Questions and Answers

STRUCTURAL Amendments to Drawings:

END OF ADDENDUM NO. 4

NEW CROATIAN CULTURAL CLUB
615 BARTON STREET
STONEY CREEK ONTARIO

FOUNDATION NOTES:

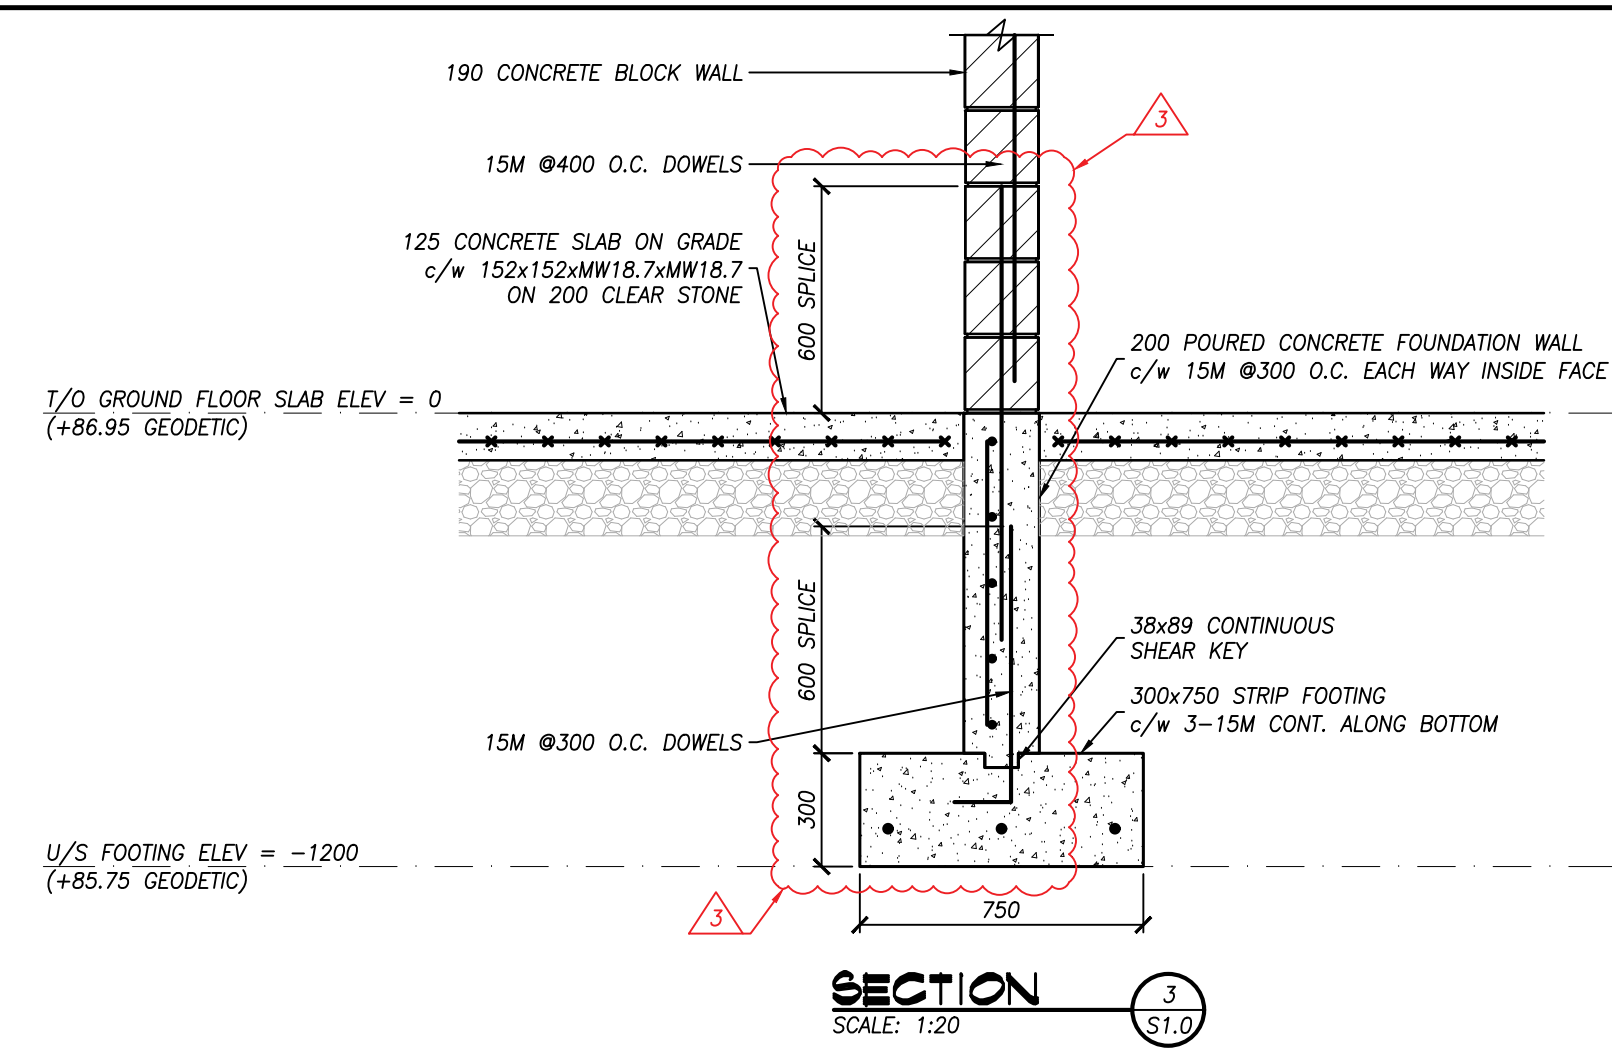
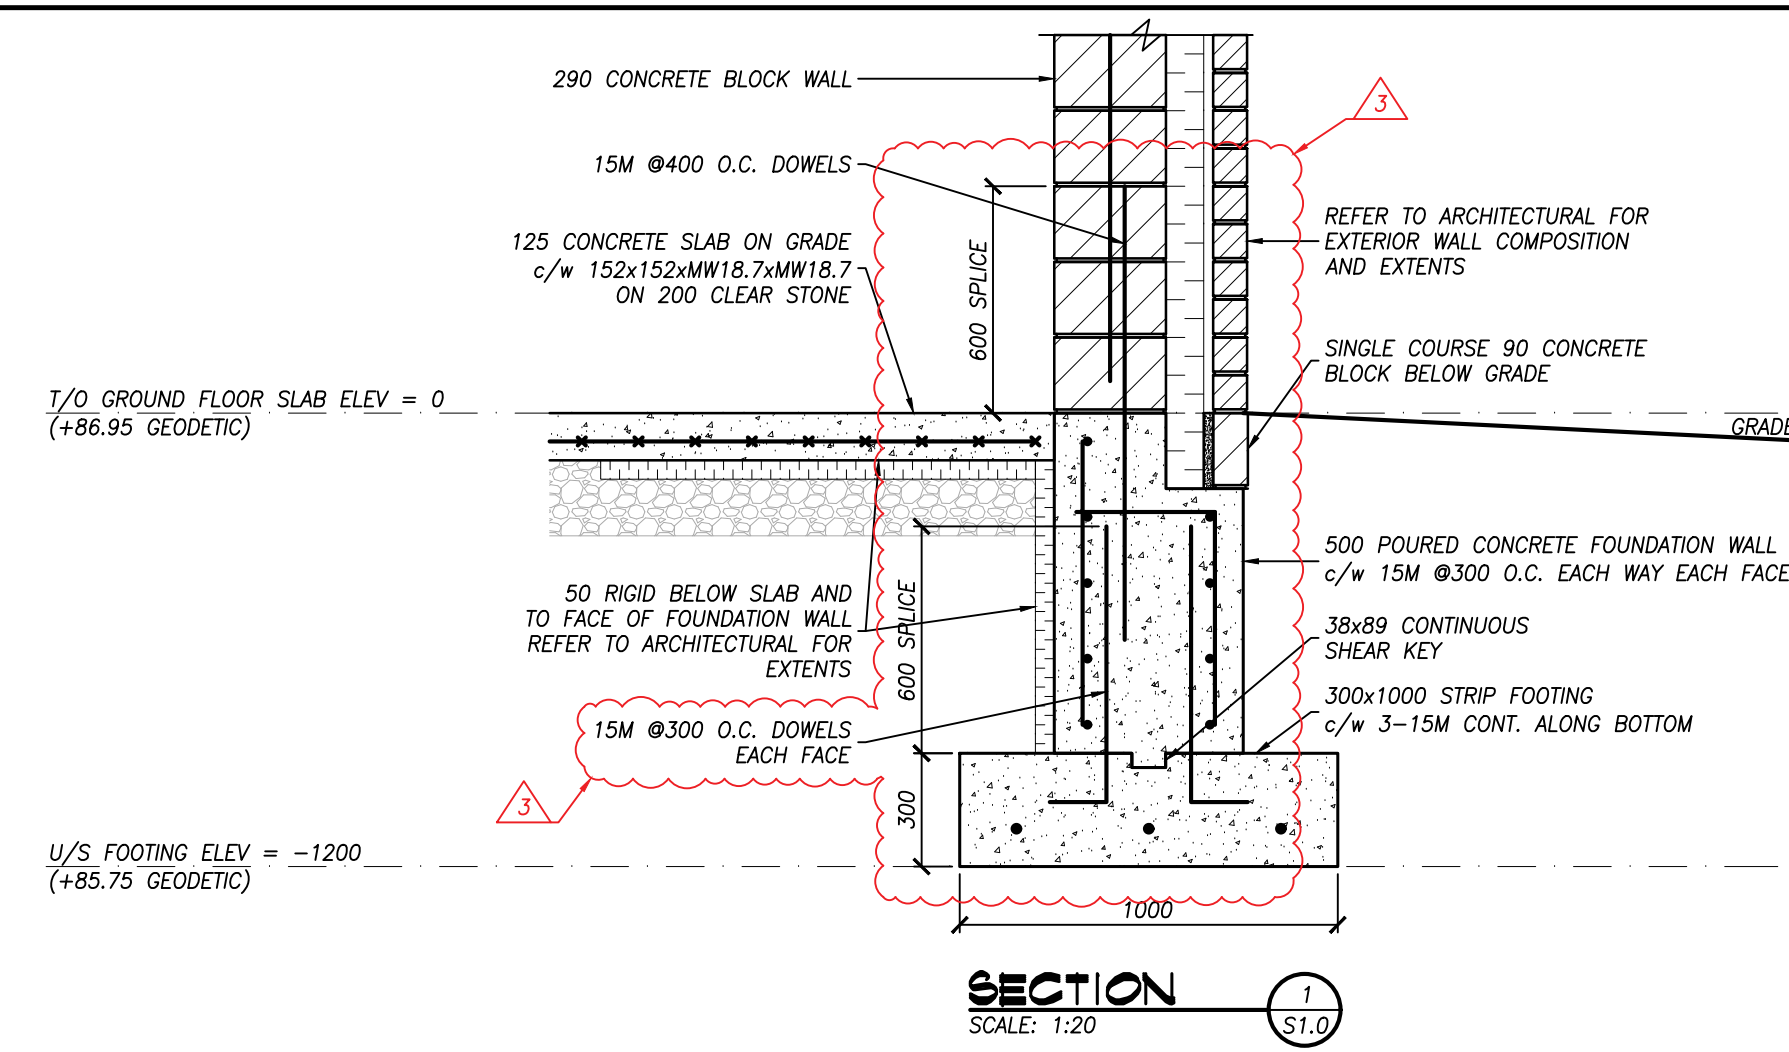
- A. Refer to sheet S1.0:
 - Updated the elevations for the sump pits.
 - Updated the extent of the raft foundation under the elevator shaft.
 - Updated the underside of footing elevations and step-down footings around the sump pits.
- B. Refer to sheet S2.1:
 - Updated section 4/S1.0 to reflect the correct elevations for foundation and slab on grade.
 - Updated the dowels and their splice length on all sections on this sheet.
